E326: EPA 17-21 MX-13 Fuel Injector Connector Upgrade

E326: EPA 17-21 MX-13 Fuel Injector Connector Repair

3/6/2025

Broken Injector Connectors in Valve Train Casing Assembly

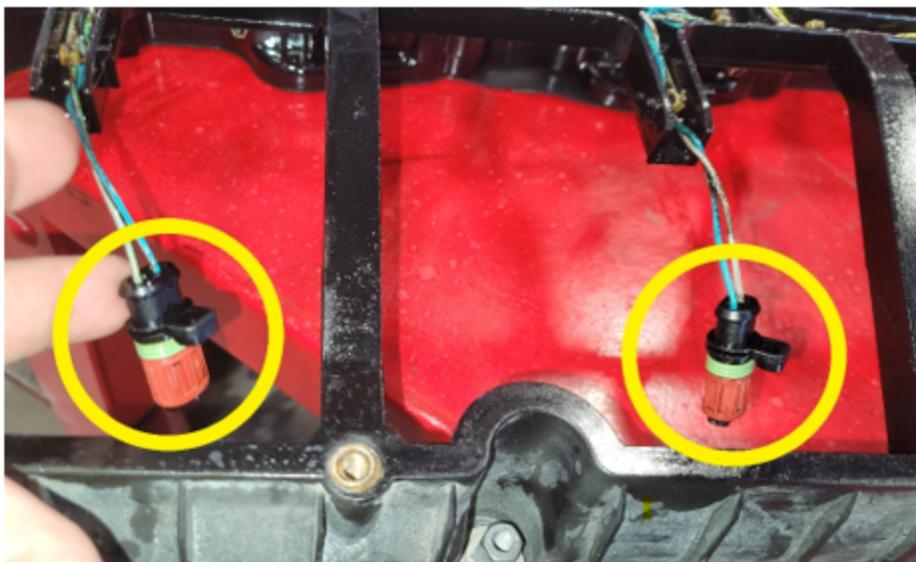
During repairs which involve disconnecting the injectors or removing the valve train casing, the injector connector shells (1439888PE) locking tabs may be broken. Since the injector connector shells were not previously available, the entire valve train casing assembly had to be replaced to fix the issue.

To prevent downtime, dealers should stock the injector connector shells (1439888PE). Replacement of

broken connector shells should occur rather than replacement of the valve train casing assembly.
